SPACE SHUTTLE HYDRAULIC SYSTEMS ASSESSMENT

Report number MDC J4610

Issue date 11 AUGUST 1978 Contract number NAS9-15550

FIGURE 3-5. DC-10 PUMP PRESSURE LINES

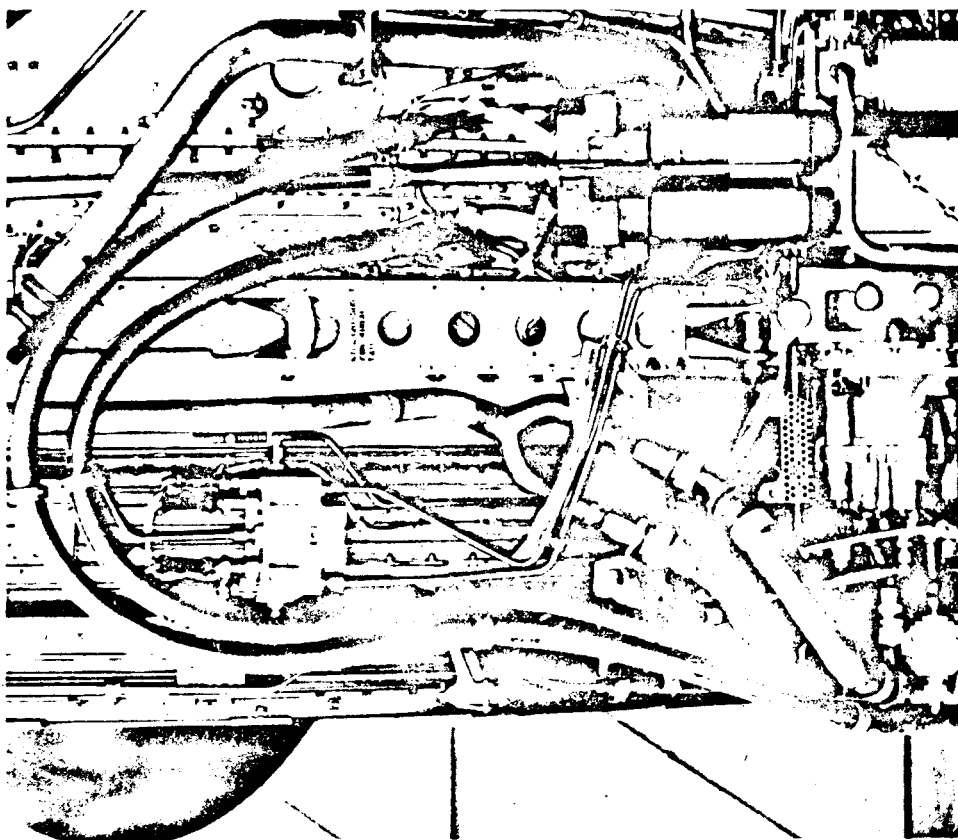
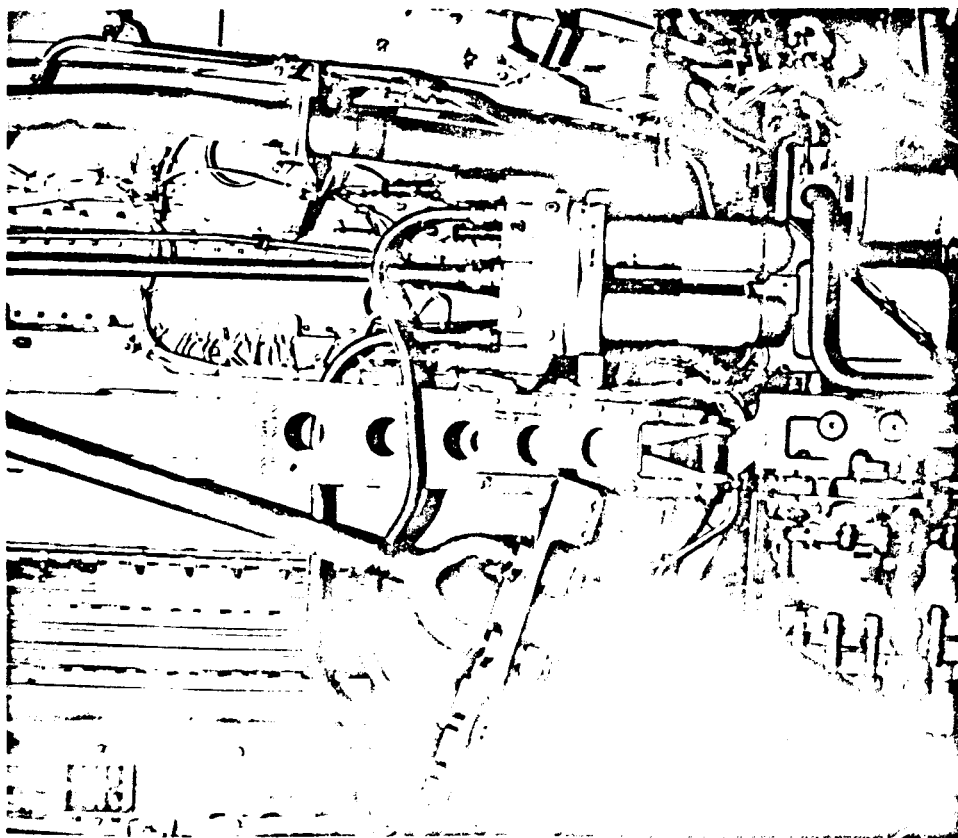
3.3.2.1.2 Pump Pressure Line Failure — The pump pressure line is a short length of hose followed by a hard line to the check valve and filter. The length of hose and hard line is within a few inches of the same length as the original Douglas DC-10 aircraft pump hose lines. The DC-10 installation developed a serious problem because of pump ripple with 1250-psi peak-to-peak pressure variations. This resulted in several line failures at a life of approximately 40 hours. After considerable analysis, and test of several configurations, a satisfactory solution was found that reduced pump ripple to 125 psi peak-to-peak yet did not reduce operating life. It consisted of a pump ripple attenuator, a small hollow spheroid about 5 inches in diameter, and a longer hose. The configurations, both before and after, are shown in Figure 3-5.

The configurations of the SRB and DC-10 pump line routings are sufficiently alike to cause concern that the SRB would encounter this kind of problem. The tests conducted on the SRB system did not incorporate a pressure transducer next to the pump. The only pressure measurement taken was inside the fluid manifold assembly using a normal response transducer. Pressure measurements were recorded only five times per second. It is most unlikely that this test would reveal the existence of a pump ripple problem.

It is recommended that pump ripple and its effect on the operating life of the line be determined. The Douglas experience with this type of problem indicates that the test article must be the same as that used in production assembly. In addition, only a high-response (10 kHz) instrument such as a Kistler pressure transducer will provide accurate data. It is furthermore necessary to display the Kistler output on an oscilloscope or continuous high-speed recorder. Pressure measurements should be made at both ends of the pump pressure line. In our experience, these things are mandatory to evaluate the problem. With an average life as low as 40 hours, the probability of a dual generic failure becomes unacceptably high. If the existing pressure line configuration has insufficient life, some combination of a longer hose and a pressure attenuator chamber may be required.

FIGURE 3-6. MANUAL SHUTOFF VALVE

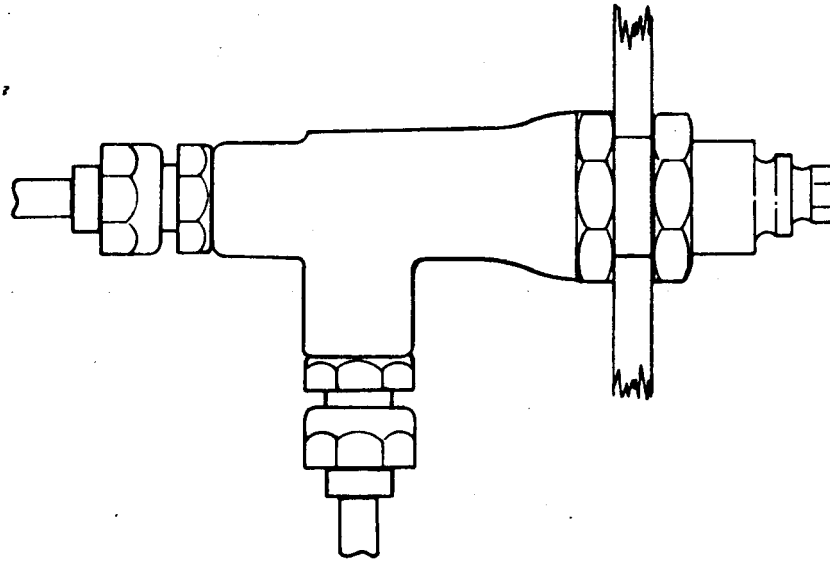
3.3.2.1.3 Manual Shutoff Valve — Two manual bleed valves are provided for each hydraulic power system on the Solid Rocket Booster. These valves are mounted by clamping the valve body in a circular hole in the service panel with a jam nut. This is shown in Figure 3-6. The valve is opened and closed by applying a wrench torque to the projecting hexagonal stem. If excessive torque is applied when opening or closing the

valve, it may rotate in the service panel. This could deform the tubing and loosen the tube fittings. This is a generic problem and could very well occur on both hydraulic systems at one time.

FIGURE 3-7. ORBITER STATION 1307 DEVELOPMENT FIXTURE

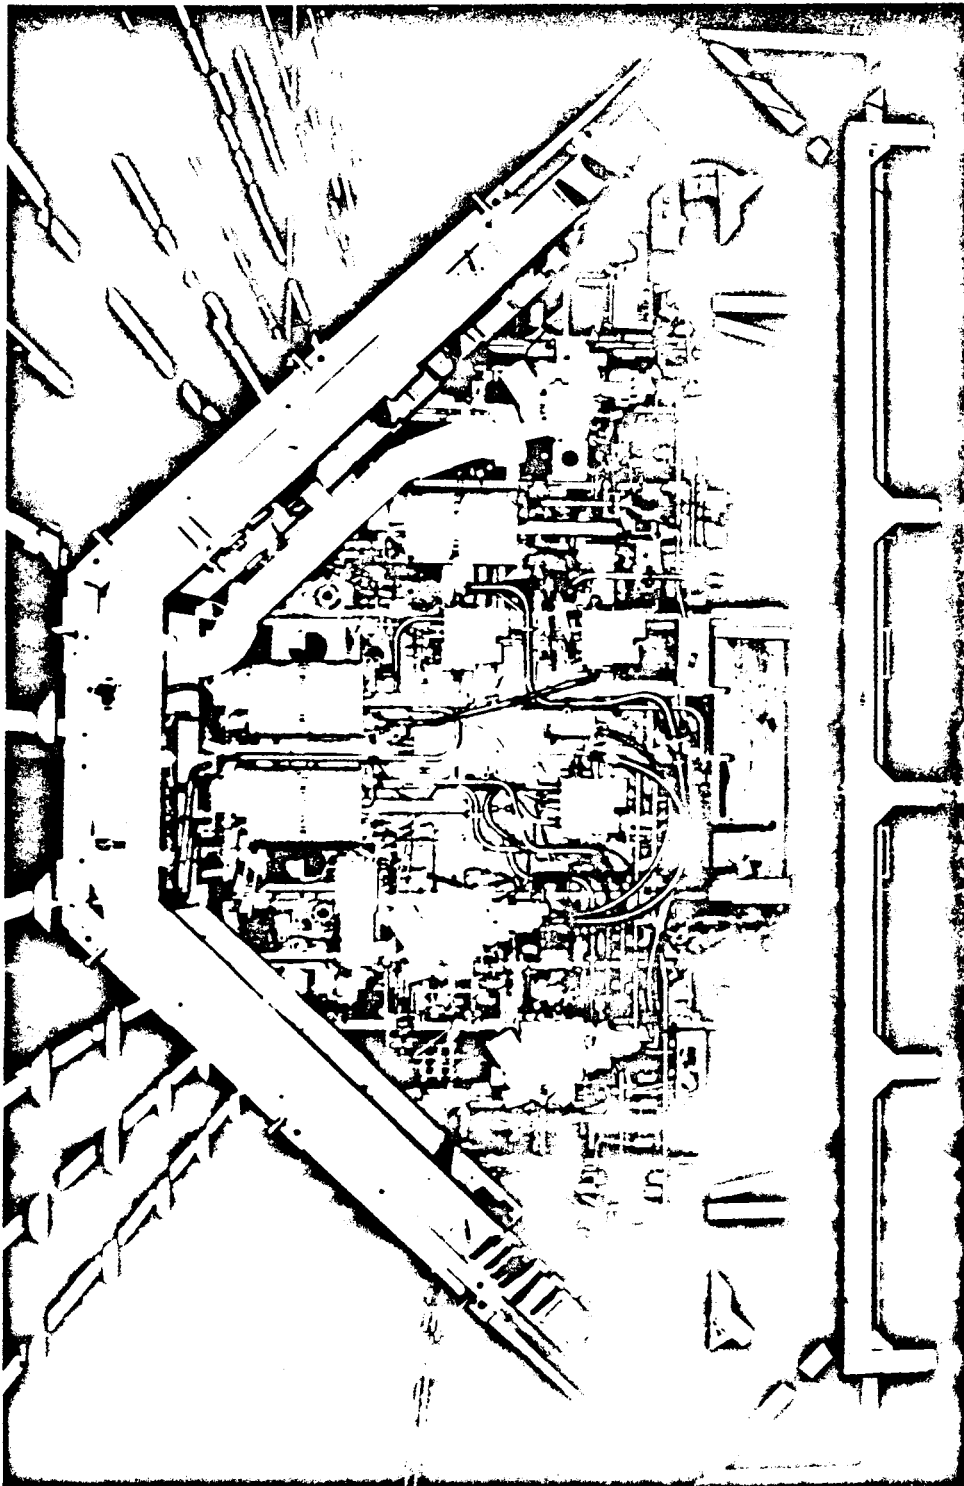
Figure 3-7 shows a manufacturing tool for development of the hydraulic power systems on Orbiter Bulkhead 1307. The bulk of the equipment for three power systems is mounted here. There is little separation of systems and many small areas have lines and components from all three systems. This means that a catastrophic event such as a turbine explosion or a fire could result in the loss of fluid from all three systems. There are also many opportunities for leakage in this small space. The three systems should be separated, each to its own area, and barriers should be used to prevent fire or high-velocity debris from crossing from one area to another.

FIGURE 3-8. WHEEL BRAKE SUBSYSTEM

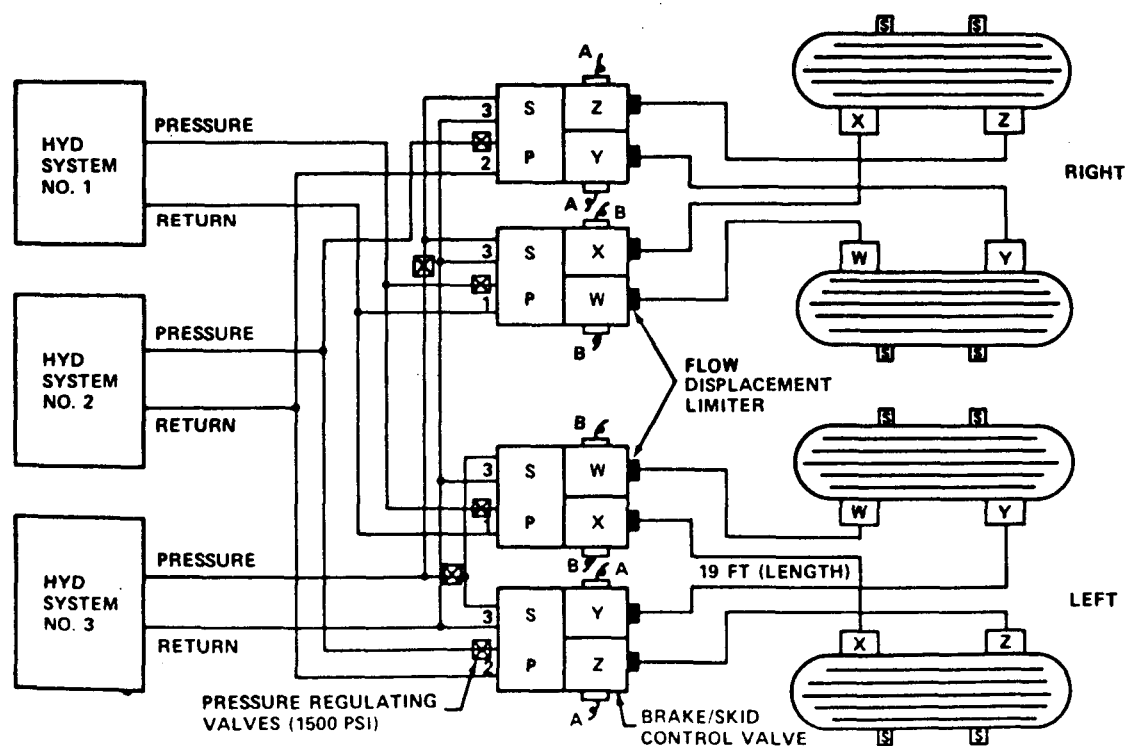
3.3.2.2.3 Landing Gear Braking System — Once the Orbiter has touched down, vehicle deceleration is accomplished by a set of brakes on each of the four wheels in the main landing gear. The braking system is designed to operate on multiple hydraulic power systems for redundancy. It also incorporates an antiskid system to attain optimum braking effort. Each hydraulic system contains a pressure reducer valve to provide 1500 psi to each brake system manifold. Displacement limiting valves are provided so that a fluid leak at any point downstream of the brake control valves will be limited. See Figure 3-8 for a schematic drawing.

1. With no brakes on one wheel (two chamber sets inoperative), the Orbiter may overrun the runway at KSC.

2. If Systems 1 and 3 or 2 and 3 are lost as a result of a single failure in the brake control valve, only half of the brake chambers are effective. With a 32,000-pound payload and the brake application started at 174 knots, the braking distance will probably be excessive.

FIGURE 3-9. MAIN LANDING GEAR HOSE LOCATION

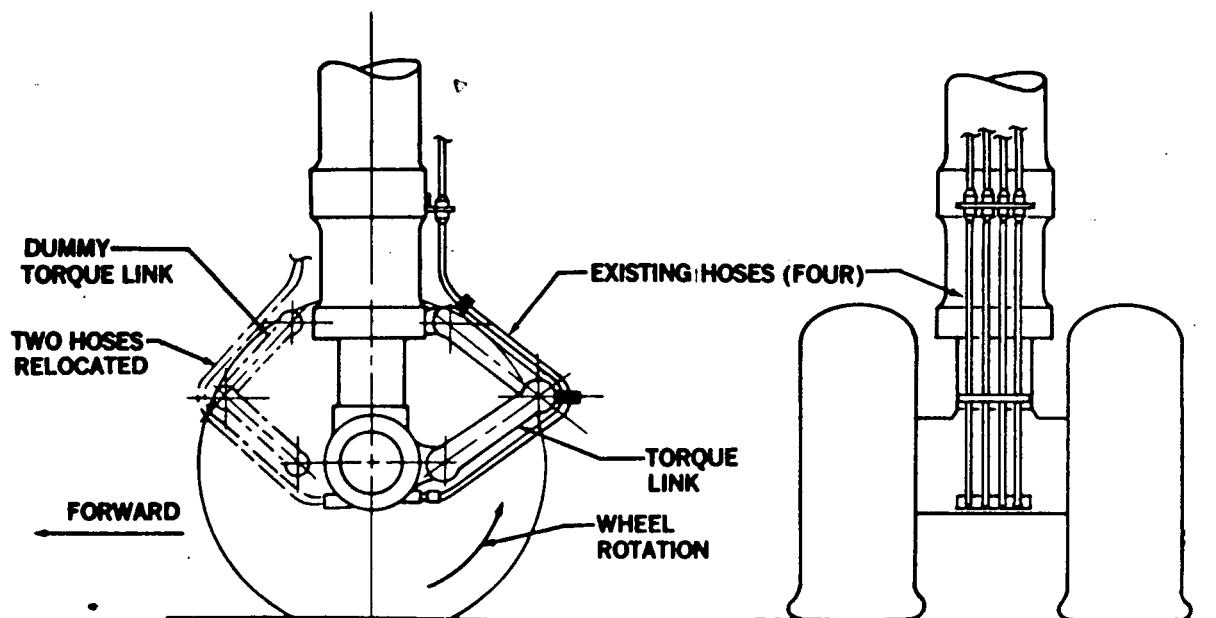
It is recommended that two brake lines be located on the forward side of the shock strut and two on the aft side. A set of dummy torque links can be used to support the forward brake hoses (see Figure 3-9). This is consistent with separation of redundant systems and is the configuration used on commercial transport aircraft.

FIGURE 3-10. BRAKE VALVE MODULE

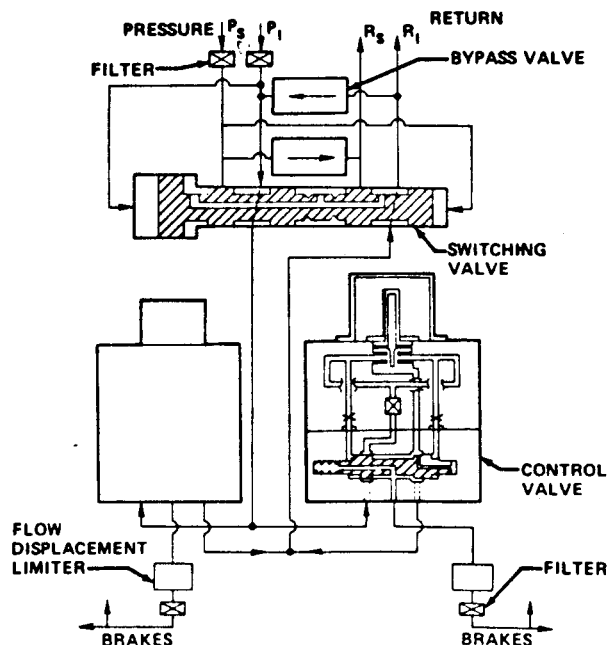
1. The brake manifold is a proprietary design and only limited examination of the drawing was possible. There are many internal drilled passages in the manifold which contain Lee plugs. Loss of these plugs or substantial leakage past them between the switching valve and the flow limiter in either pressure or return passages could result in the loss of P_1 and P_s .

- Add backup locks to ensure plug retention and a leakage barrier. Provide a rip stop design on the valve housing.

FIGURE 3-11. BRAKE/SKID CONTROL SWITCHING VALVE

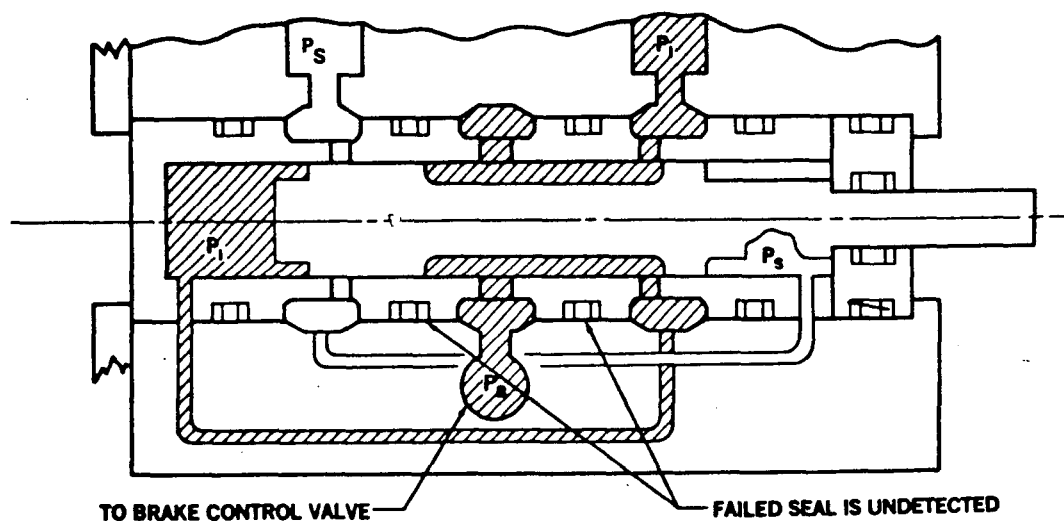
2. In the brake switching valve, there are seals on either side of the brake control valve chamber (see Figure 3-11). A failure of either seal will not be detected since there is normally no pressure difference across them. If there is a ruptured line in P_1 or P_s , the failure of the adjacent seal will permit fluid in the brake control valve chamber to be leaked overboard. This will result in a loss of both P_1 and P_s hydraulic power systems.

- Provide check valves at each inlet to the brake control valve module (preferred, cost-effective).
 - Reduce the diametral clearance between switching valve sleeve and its housing. This barrier may reduce leakage to an acceptable level.
3. It was observed that threaded port plugs were locked with Long-Lok inserts. It is questionable whether these locks will remain effective for the 10-year service life of the operational system. Loss of these plugs could result in the loss of the P_1 and P_s systems.

- Lock-wire all external plugs and caps.

**FIGURE 3-12. ACTUATOR POSITION MECHANICAL FEEDBACK
BIAS SPRING INSTALLATION**

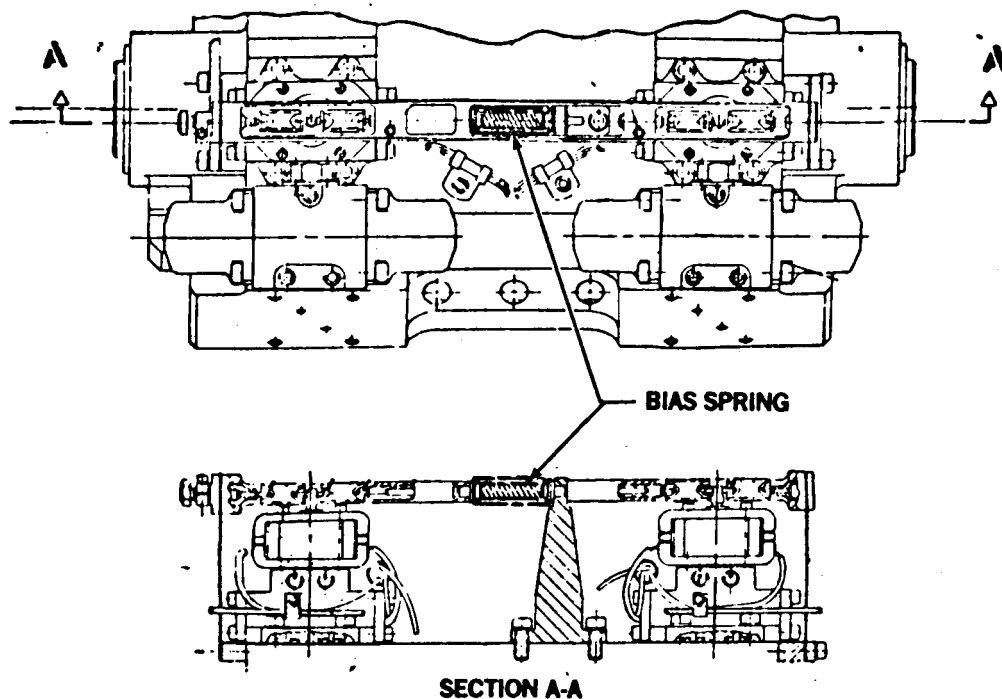
This problem was reported to NASA-MSFC and NASA-JSC and corrective action is being taken.

FIGURE 3-13. SRB-TVc ACTUATOR PISTON

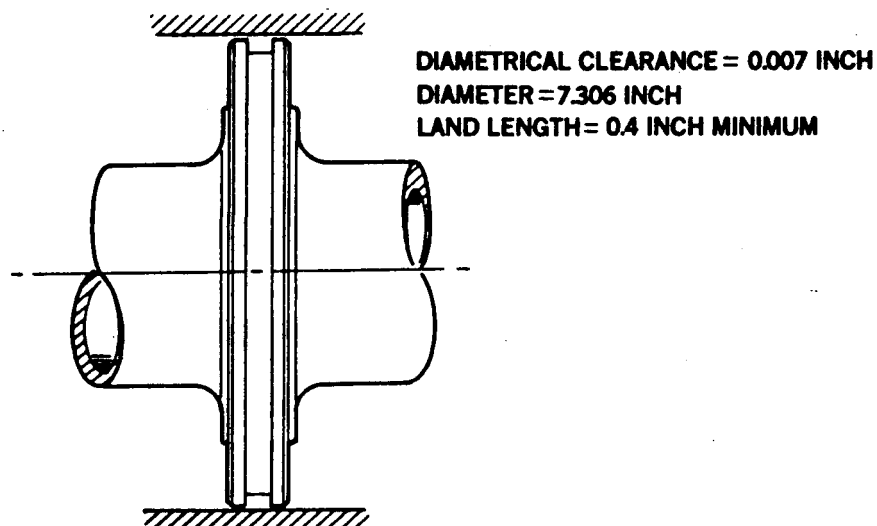
3.3.3.3 SRB TVC Actuator Piston Head Internal Hydraulic Seal Failure — The SRB TVC actuator piston head seal (Figure 3-13) is a dynamic seal with the actuator control pressure applied across the seal. A failure of the seal can allow internal leakage in excess

of 20 gpm to occur. This would create a Criticality Category 1 condition since loss of control of the actuator and vehicle would occur.

FIGURE 3-17. SRB-TV SWITCHING VALVE

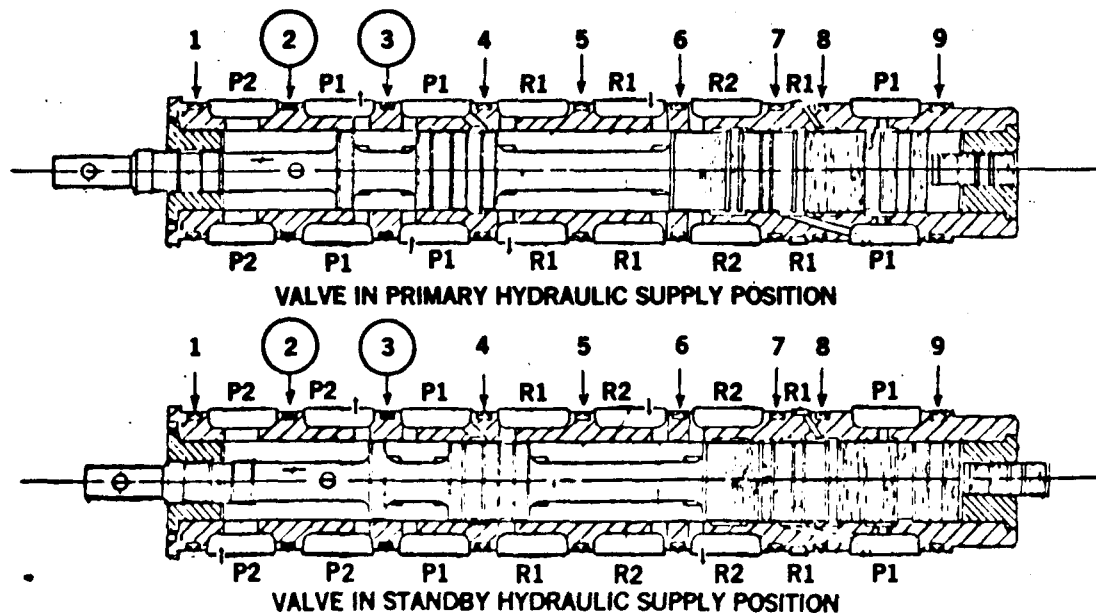
3.3.3.5 SRB TVC Switching Valve External Hydraulic Seal Failure — The SRB TVC actuator switching valve has two seals, No. 2 and No. 3 (see Figure 3-17), which are considered single failure points and are classified as having a Criticality Category 1U failure mode. A 1U category is an undetected failure that requires a second failure to occur before the undetected failure becomes critical to the vehicle and crew. A failure in Seals 2 and 3 would be undetected since primary and standby system supply pressures exist on both sides of the seals. Any difference in pressure between the two supply pressures will cause a small flow of fluid from one system to the other since system pressures would not be exactly identical. This will cause reservoir levels to change slightly during the 144-second APU operating time in ascent. If standby supply pressure is lost and Seal 2 fails prior to the loss of standby pressure, then the primary pressure will be lost with hydraulic fluid flowing across the failed seal and overboard through the standby system leakage failure point. Likewise, if Seal 3 fails and an external leak occurs in the primary supply, then the standby supply will be lost after the valve spool transfers, allowing the standby fluid to pass through the failed seal and overboard through the failed primary supply leakage path. Actuator control is not lost if only the primary hydraulic system is lost; however, with an undetected seal failure that allows the loss of the standby system, then the crew would lose control of the actuator and vehicle.

A failed seal allows an external leakage flow rate of 23 gpm. The maximum allowable on the SRB is 2 gpm. An external leakage flow greater than 2 gpm will drain the primary and standby hydraulic reservoirs, thus losing gimballing control of the booster for the remainder of ascent flight. MSFC ran seal failure leakage tests, and the test data are presented in Figure 3-14. The test specimen characteristics and test conditions are those of switching valve Seals 2 and 3. Extrapolating the leakage flow tests to a differential pressure of 3000 psi across the lands produces a leakage flow rate of 23 gpm.
